Westminster House

Minor Material Amendment Design and Access Statement

25 November 2024

Issue 2

Level 04 Plan - Proposed
Changes highlighted

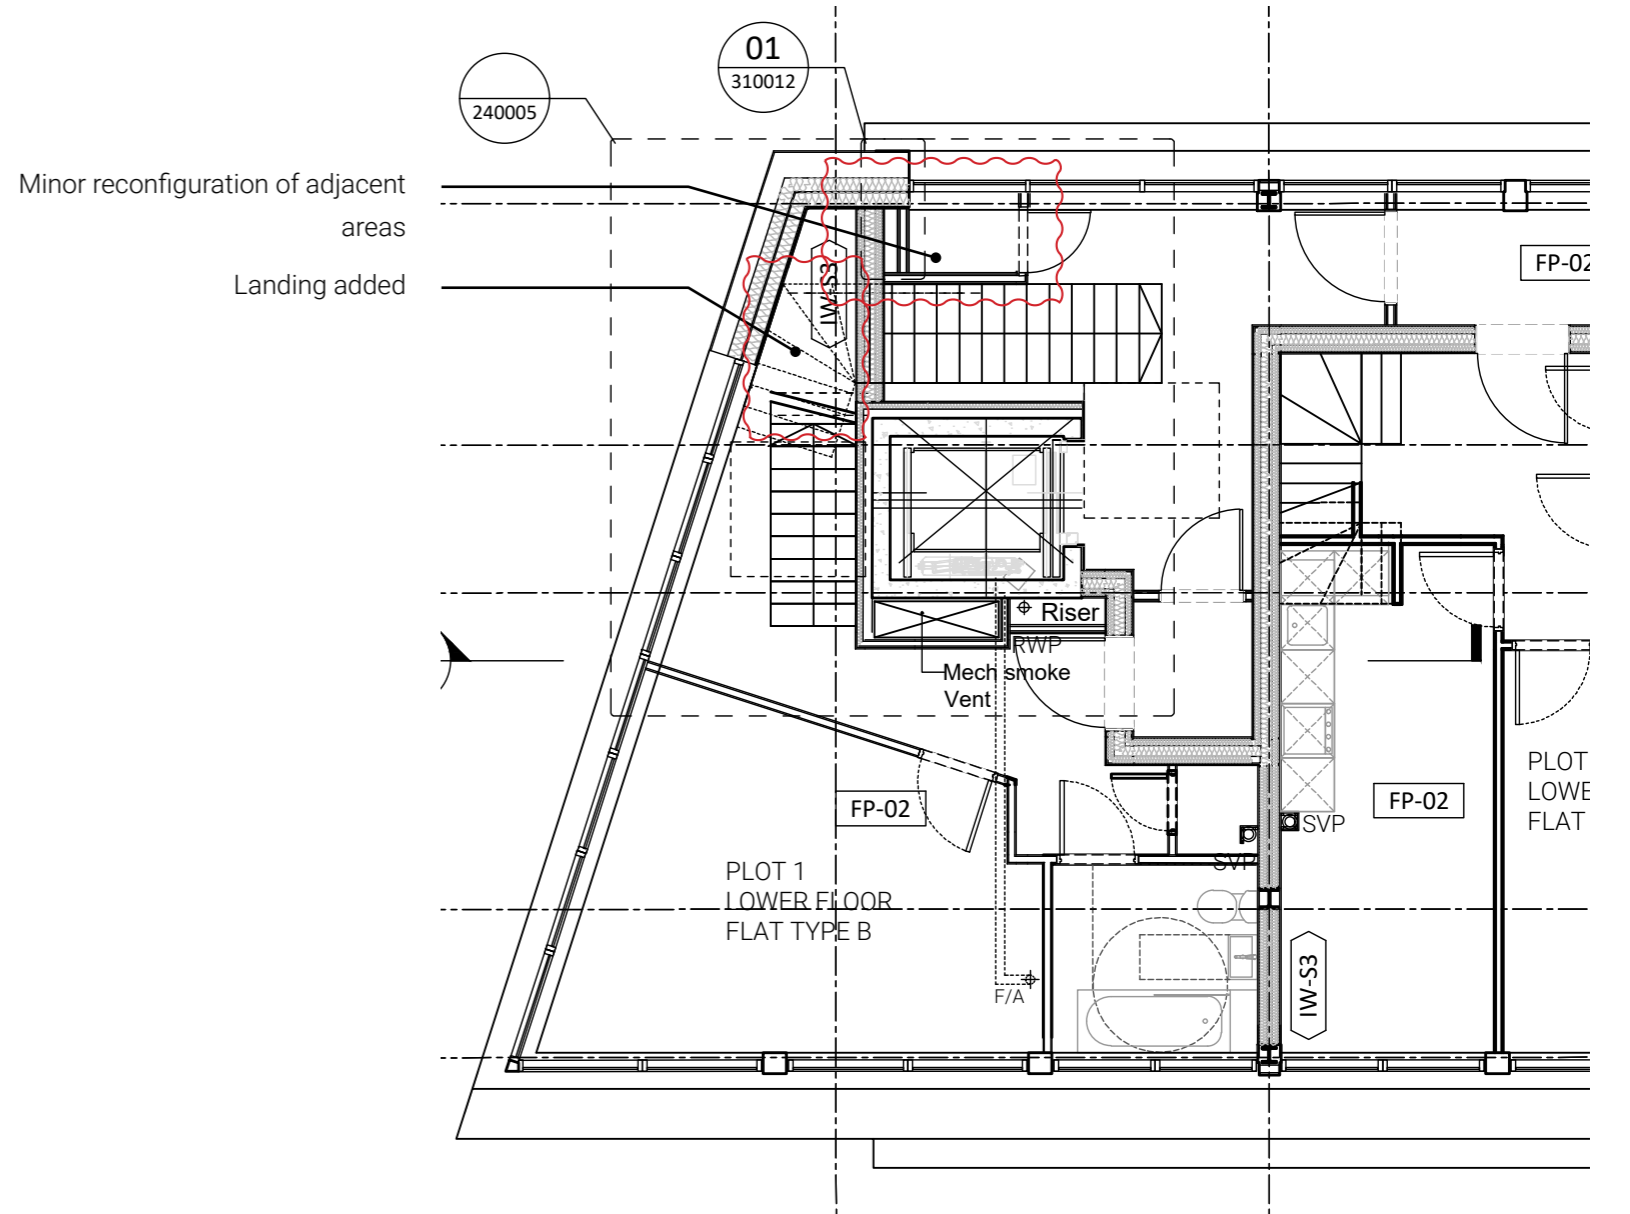
For common residential stairs, Part M4(2) of the Building Regulations requires risers of maximum 170mm in height, and single flights of no more than 16 risers. We have added these half-landings to the new stairs on level 4 but have sought to keep risers throughout the building consistent with existing step heights of 185mm as this was considered - following consultation with the Registered Building Inspector - to be a more sensible and safer approach.

Level 00 Plan - Proposed
Changes noted

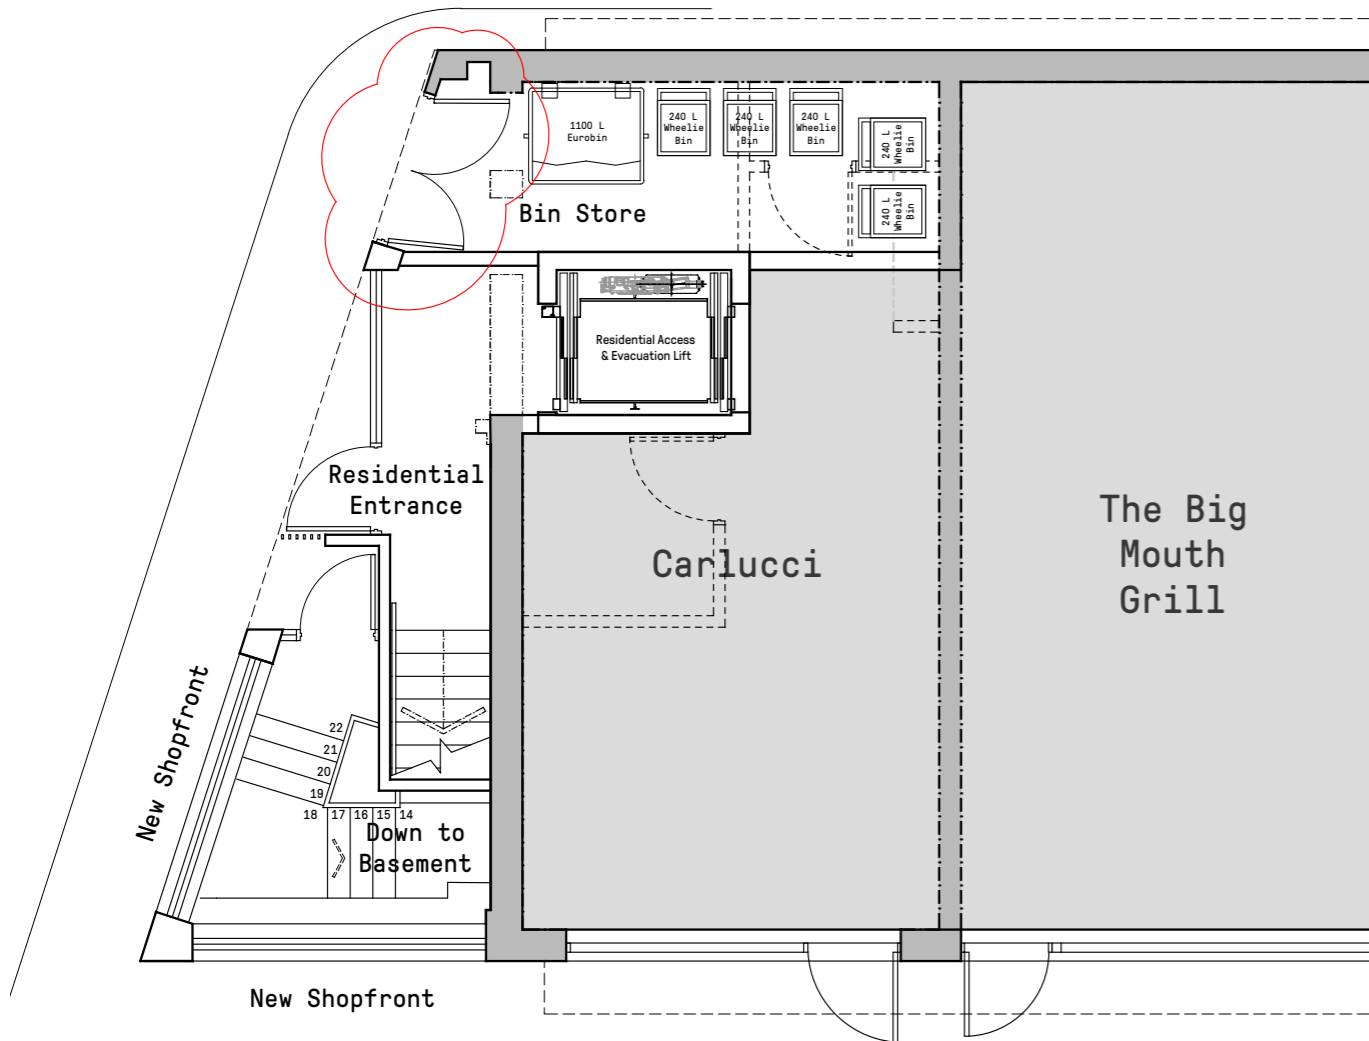
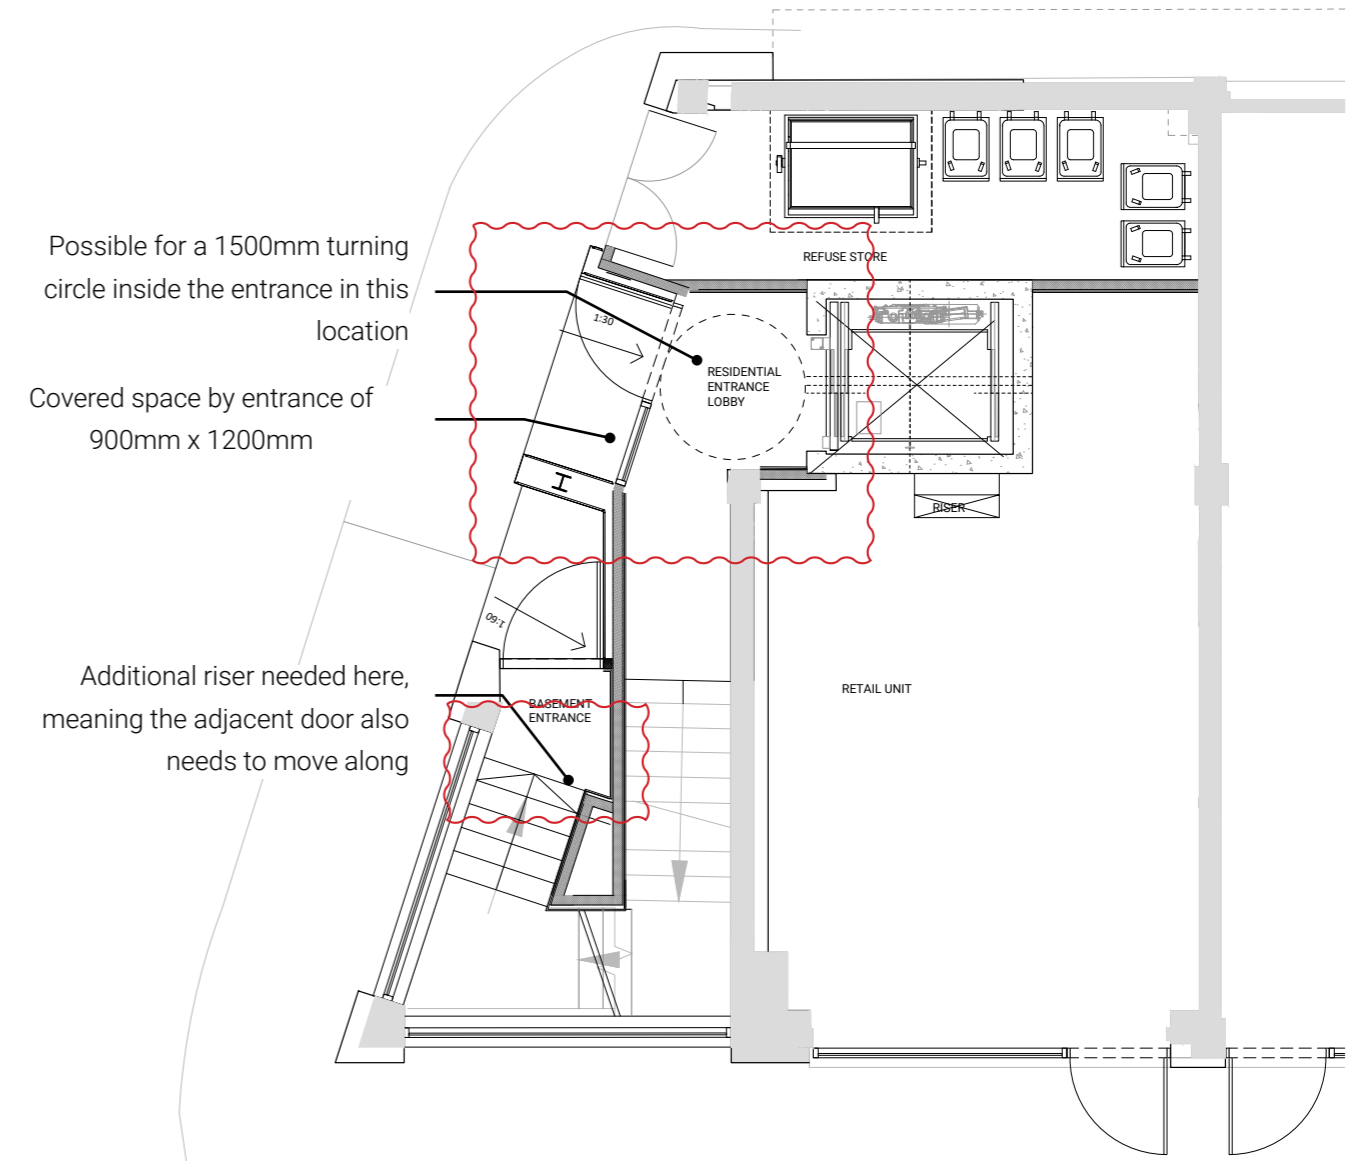
In reviewing pavement levels adjacent to the common entrance, and in line with the above approach to risers, we have had to add an additional step between the basement and ground floor, meaning there is less space to the main lobby. The requirement for a 900mm deep canopy and 1500mm turning circle - as well as an outward opening door - has meant some small amendments to this area as well. In proposing these changes, we have aimed to keep the design as close as possible to the original intent, and if anything aim to make the entry sequence more comfortable.

Kew Road Elevation - Proposed

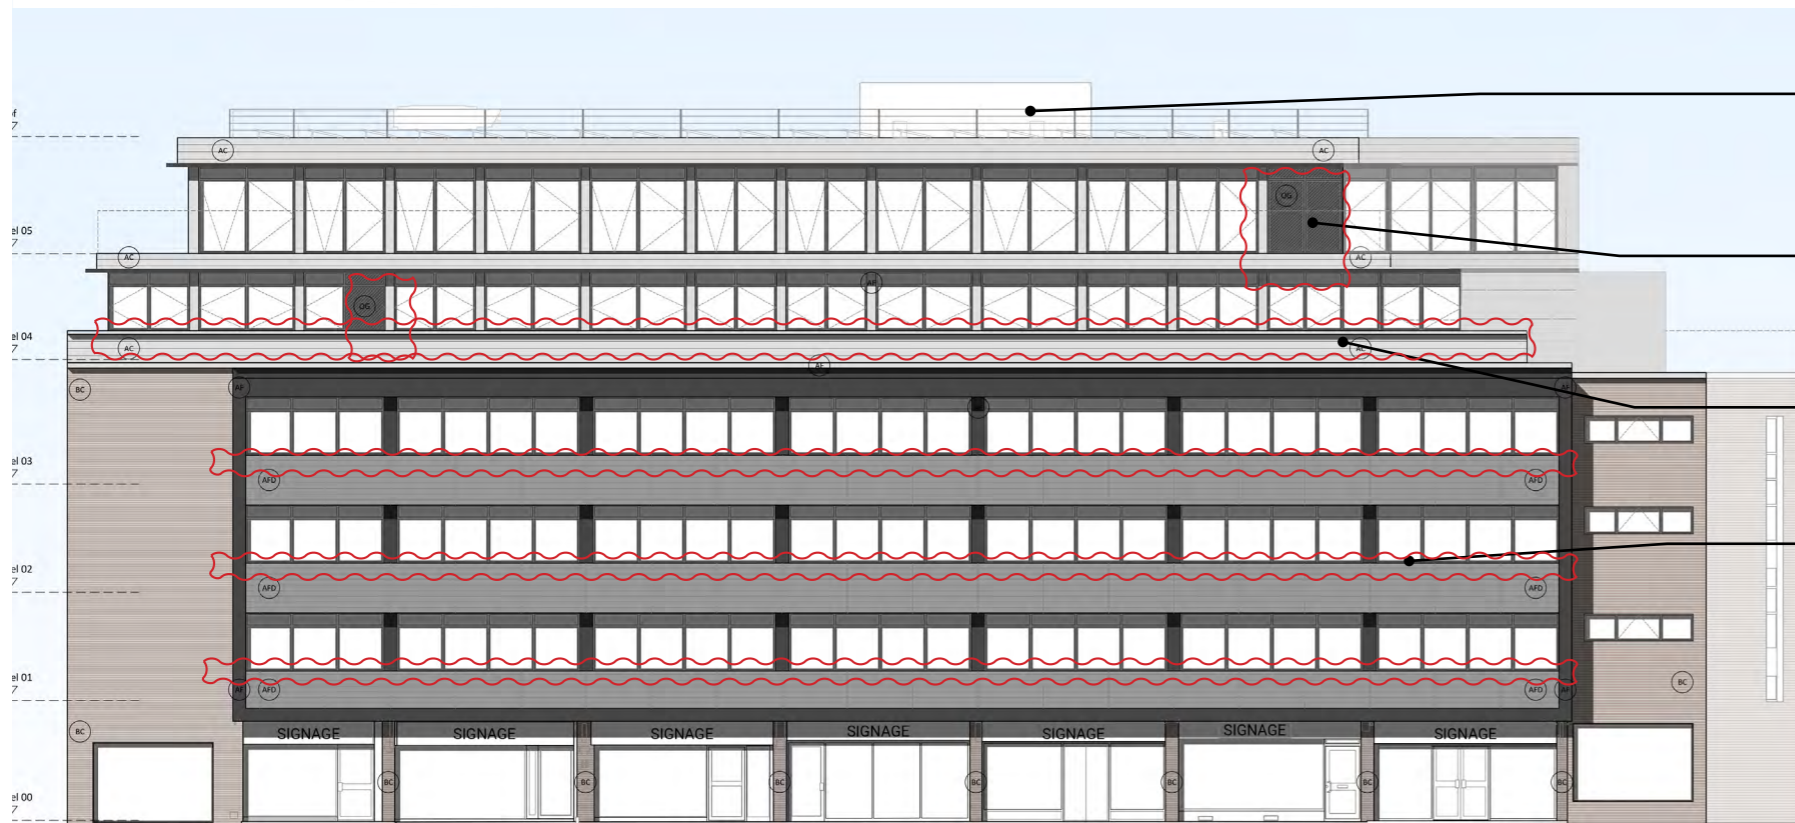
Bath and vanity unit located behind these two windows mean that they cannot be full height clear glazing - shown instead as opaque glazing. These will be largely hidden by the set back and balustrade.

Cill height at level 04 raised so that opening sections (required to give purge ventilation to these residential flats) is at the minimum 800mm above finished floor level.

Small window cill height adjustment so that cills to offices start at 800mm to meet building regulations, and to avoid clashes between window heads and the existing floor beyond

Rear Elevation - Proposed

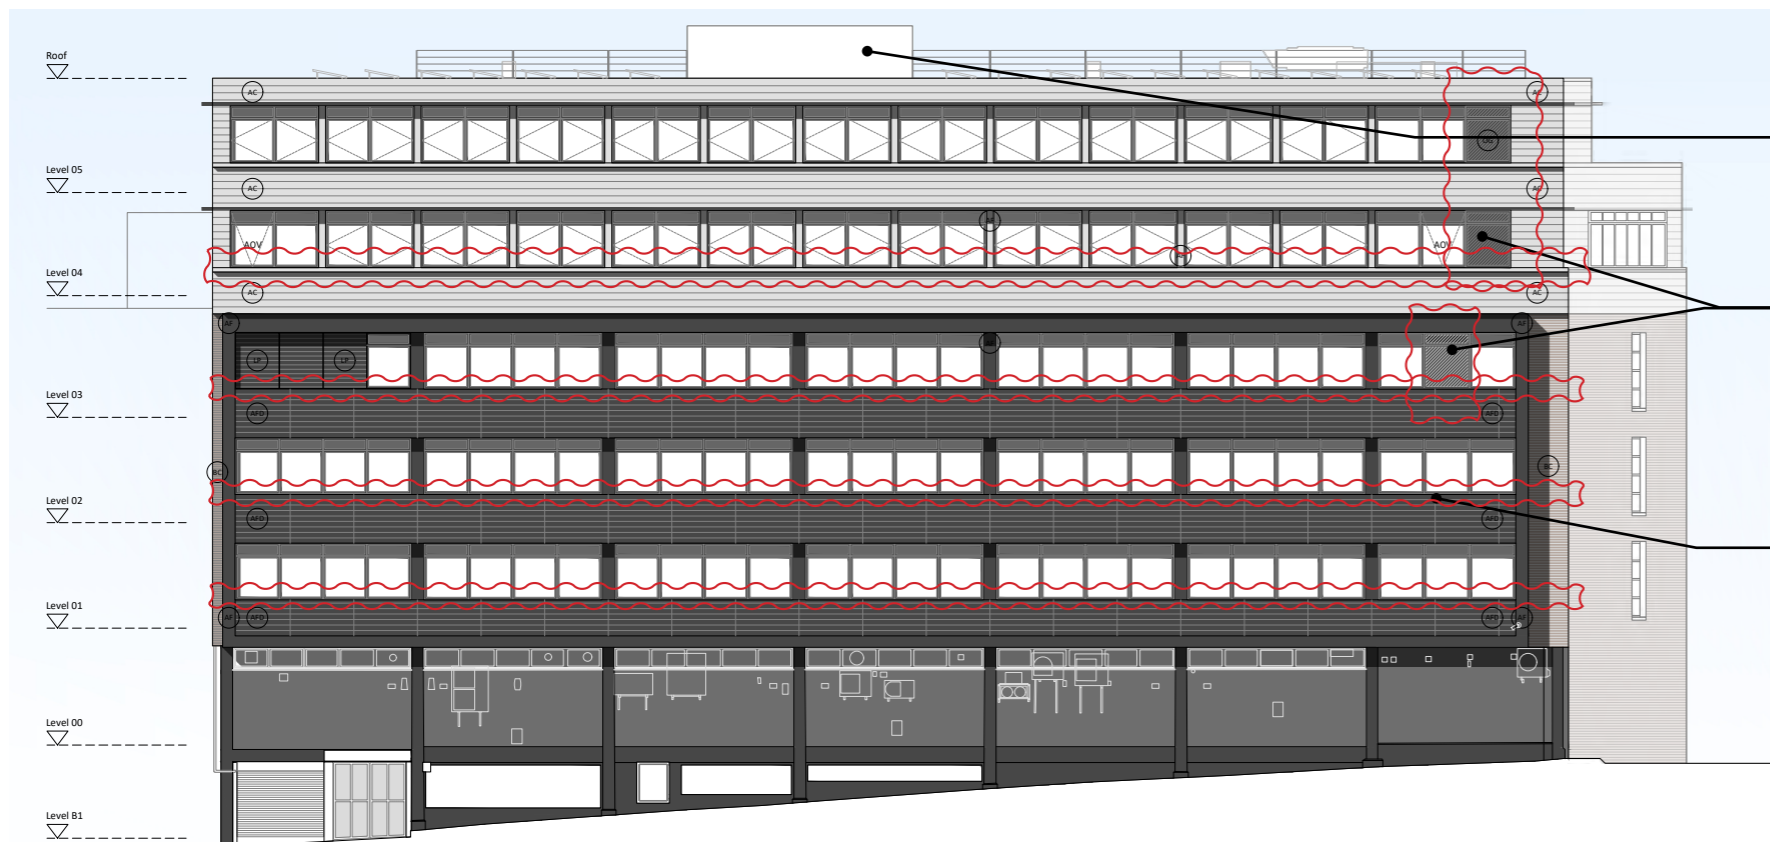
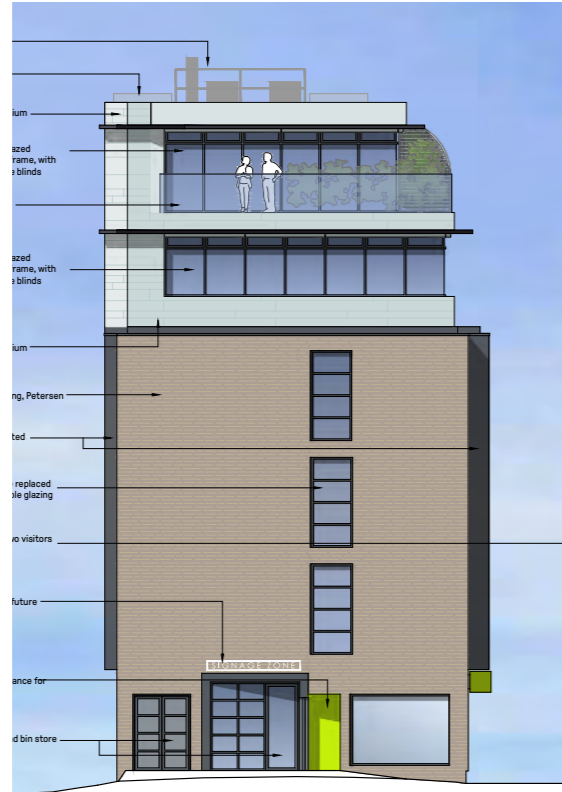
There is a wall that sits directly behind these windows which also needs to be fire rated, meaning, it cannot just abut the frame. As a result, an opaque panel is needed to hide the fire resisting wall immediately behind.

Small window cill height adjustment so that cills to offices start at 800mm to meet building regulations, and to avoid clashes between window heads and the existing floor beyond

Rear Elevation - Proposed

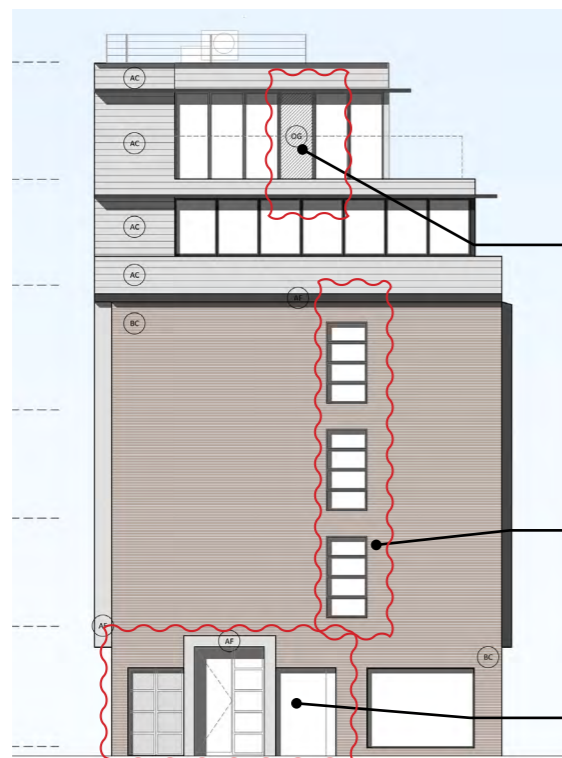
There is a wall that sits directly behind these windows which also needs to be fire rated, meaning, it cannot just abut the frame. As a result, an opaque panel is needed to hide the fire resisting wall immediately behind.

Window head heights reflect existing slab levels and build-ups

Basement Plan - Proposed

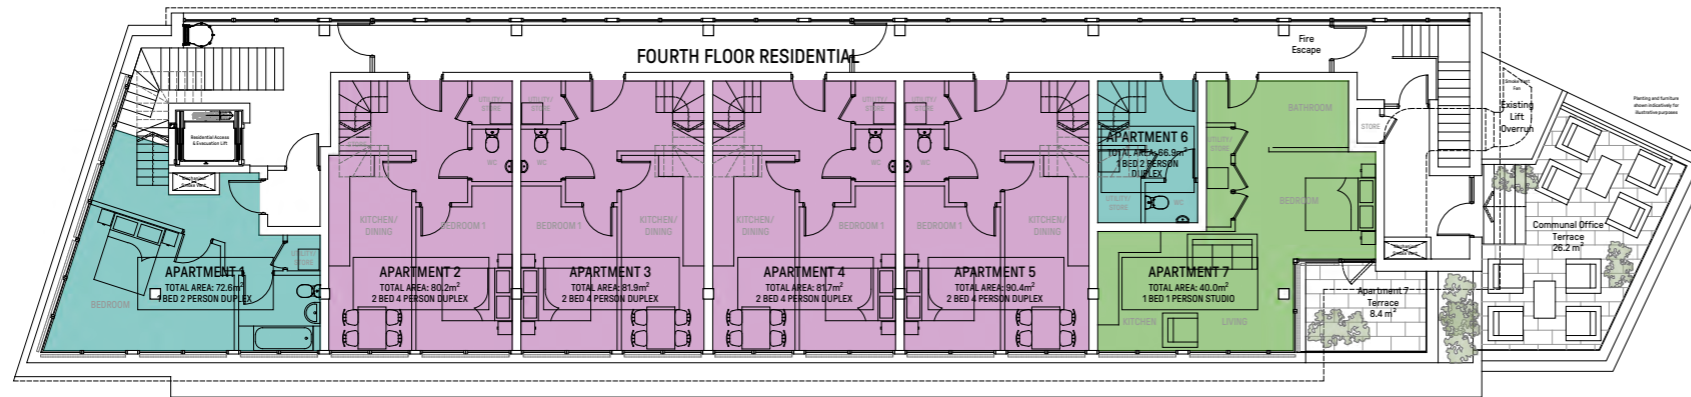
Door moved one meter so all bins can be accessed (refer to the submission for the [refuse store layout planning condition ref: U0182946](#))

More of a landing needed free of door swings for wheelchair users here

Plant room door moved as access corridor too narrow otherwise

The office cycle store on the left has been made slightly larger, and the residential store on the right, slightly smaller accordingly, as this allows the single space Sheffield stand to fit better in the space. The 'nook' in the corner has also been omitted which also helps give a little more space to access the substation. No change in number or type of cycle spaces provided. Refer to the submission for the [cycle parking condition ref: U0182947](#)

Minor changes to stairs to meet building regulations part K

Level 04 Plan - Proposed

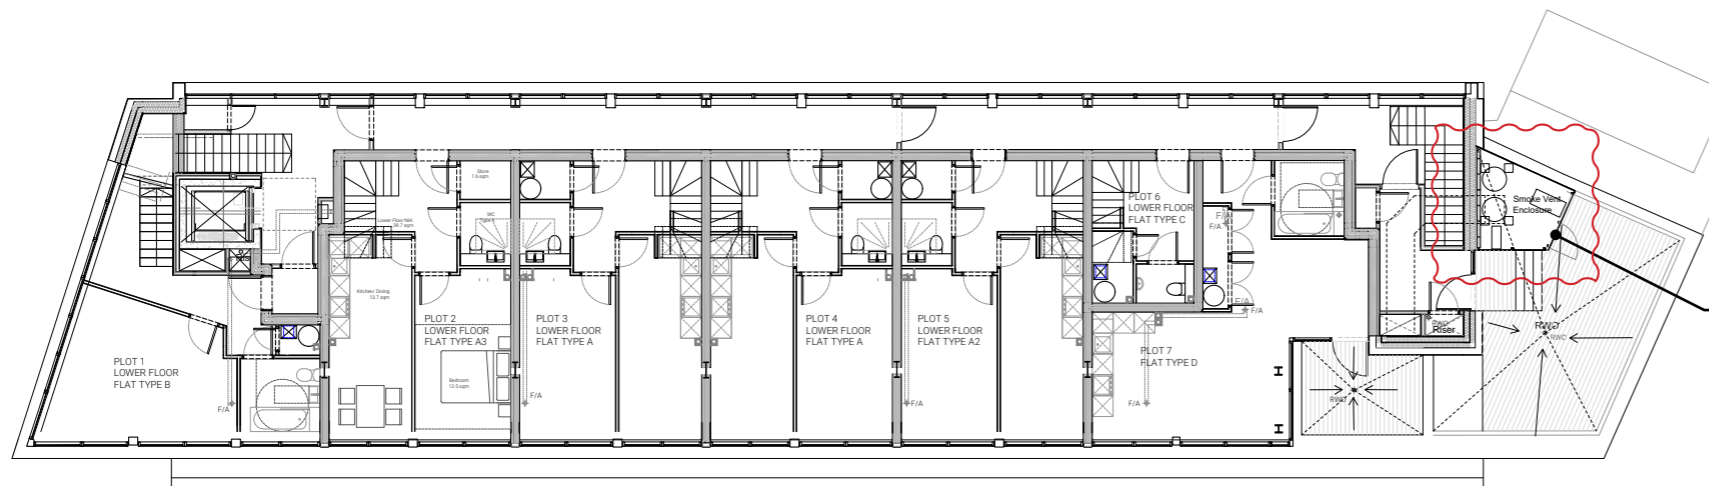
Plant enclosure enlarged to cater for manufacturer confirmed smoke vent dimensions and added noise attenuation. Plant to be secured via discharge of [planning condition U0182941](#). Materials and design details to be secured via the discharge of [planning conditions BD12 and U0182935](#)
